Number: V2500-NAC-36-0004

SUBJECT: "MODIFICATION SERVICE BULLETIN" - "NACELLE - POWERPLANT - ECS SENSE
LINE SUPPORT BRACKET - MODIFICATION OF"

"MODIFICATION SERVICE BULLETIN" - "NACELLE - POWERPLANT - ECS SENSE LINE
SUPPORT BRACKET - MODIFICATION OF"

ECS Sense Line Bracket Modification
Figure 1 (sheet 1)

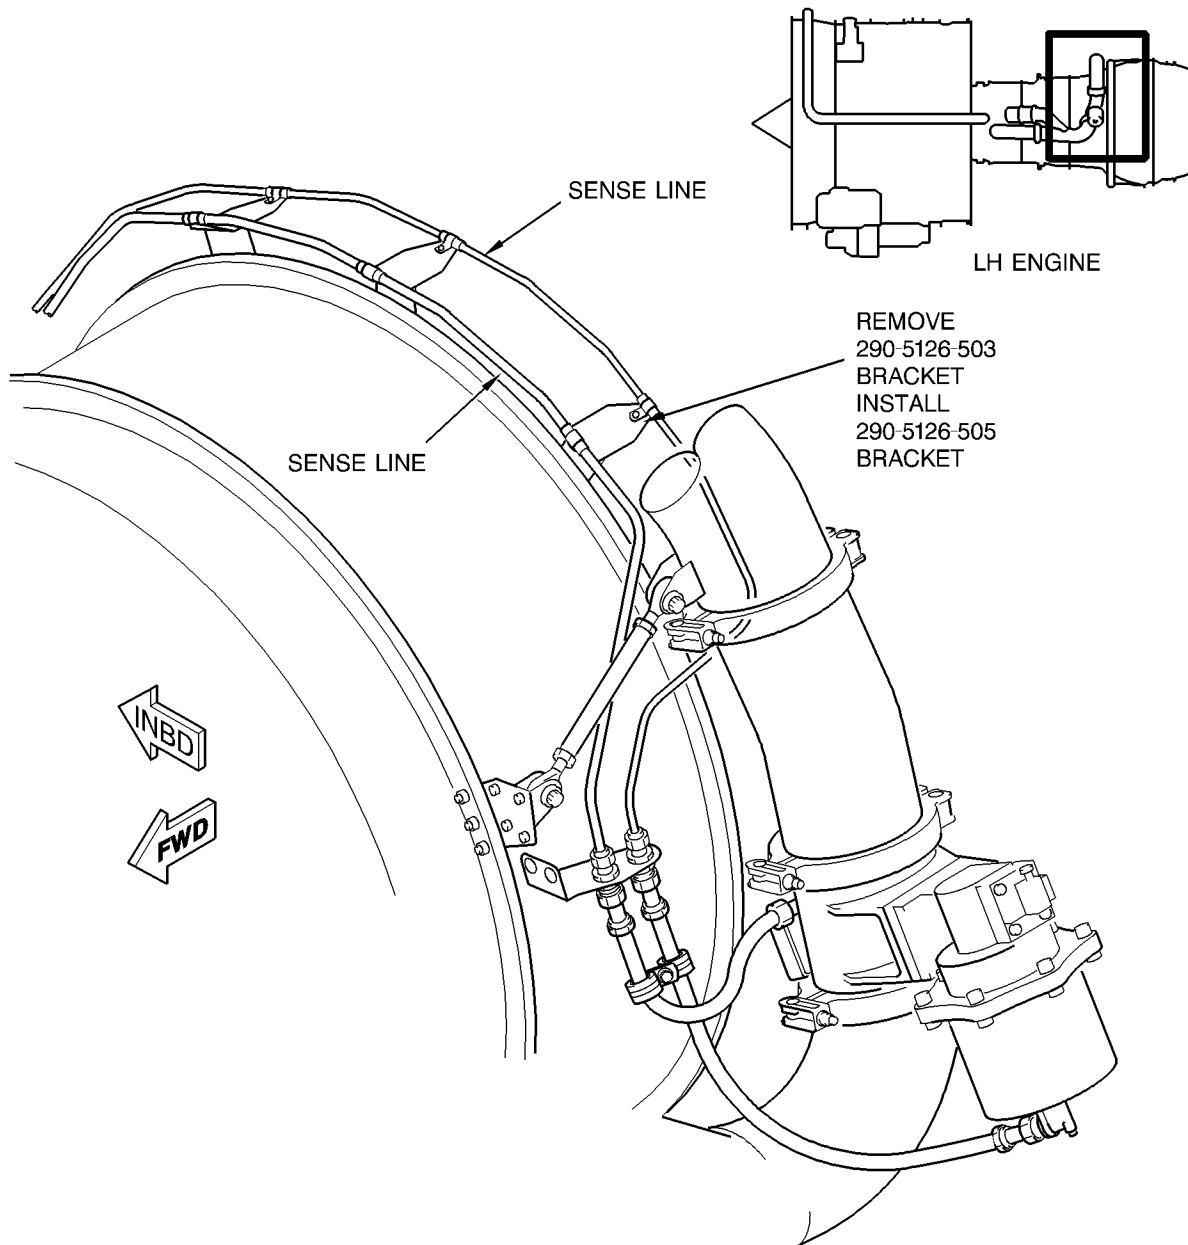
- A. Open the thrust reverser halves. Refer to the MD-90 Aircraft Maintenance Manual, Chapter 78-32-00, Page Block 201.
- B. Remove the ECS sense line from the indicated bracket. For the LH engine, refer to Figure 1 (sheet 1). For the RH engine, refer to Figure 1 (sheet 2).

- C. Remove the indicated bracket from the engine brackets. For the LH engine, refer to Figure 1 (sheet 1). For the RH engine, refer to Figure 1 (sheet 2).

- E. Install the 290-5126-505 bracket on the engine bracket. For the LH engine, refer to Figure 1 (sheet 1). For the RH engine, refer to Figure 1 (sheet 2).

- F. Install the ECS sense line on the 290-5126-505 bracket. For the LH engine, refer to Figure 1 (sheet 1). For the RH engine, refer to Figure 1 (sheet 2).

ECS Sense Line Bracket Modification
Figure 1 (sheet 3)

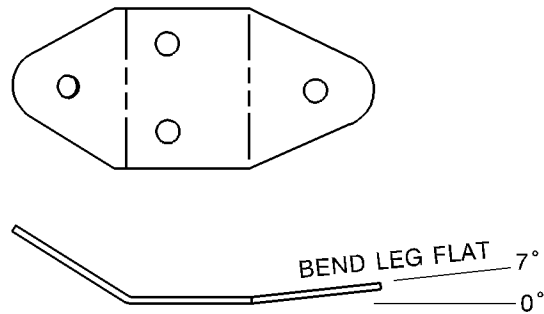
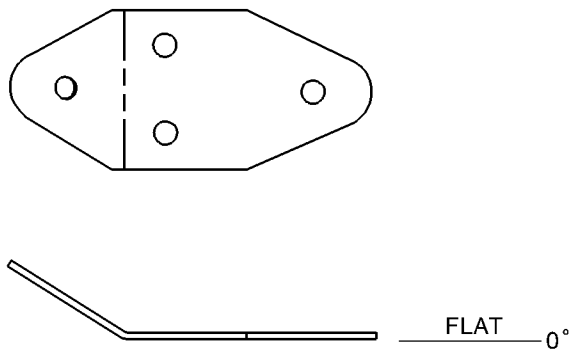
- D. Modify the bracket.
 - (1) Bend the bracket as shown in Figure 1 (sheet 3).
 - (2) Do a 10X visual inspection of the bracket for cracks. Replace the bracket if you find cracks.

- (3) Re-identify the 290-5126-503 bracket as the 290-5126-505. Use a rubber stamp and ink. Refer to the IAE V2500 Standard Practices/Processes Manual, Chapter 70-09-00.
